### ADDENDUM #1

# CONCRETE SLAB PLAN

BOLIVAR MAINTENANCE BUILDING RENOVATION  
2816 West Broadway  
Southwest District - Polk County

A  
2

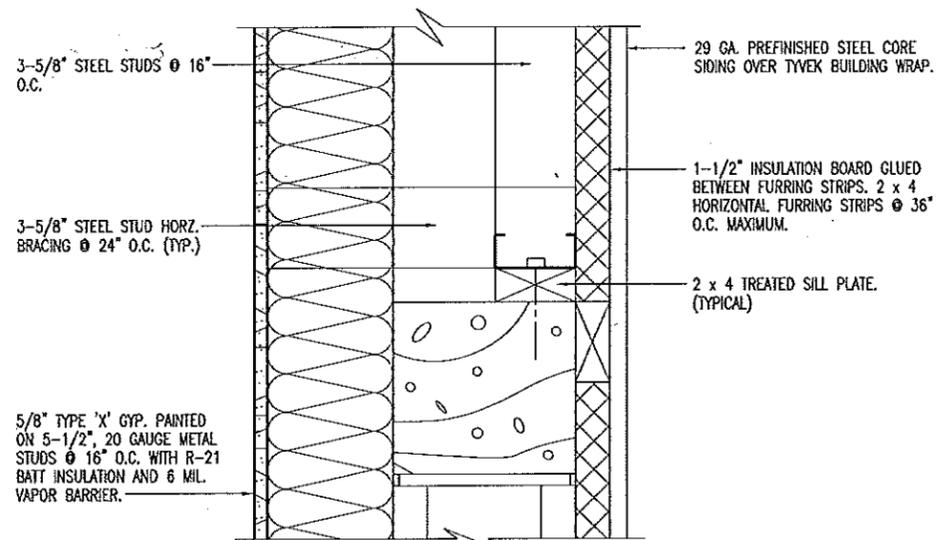
TYPICAL AT EACH GARAGE  
DOOR TO BE REMOVED TO  
EAVE HEIGHT.

TYPICAL AT EACH WINDOW  
TO BE REMOVED TO EAVE  
HEIGHT.

ADDENDUM #1  
IF ALTERNATE "B" IS ACCEPTED.
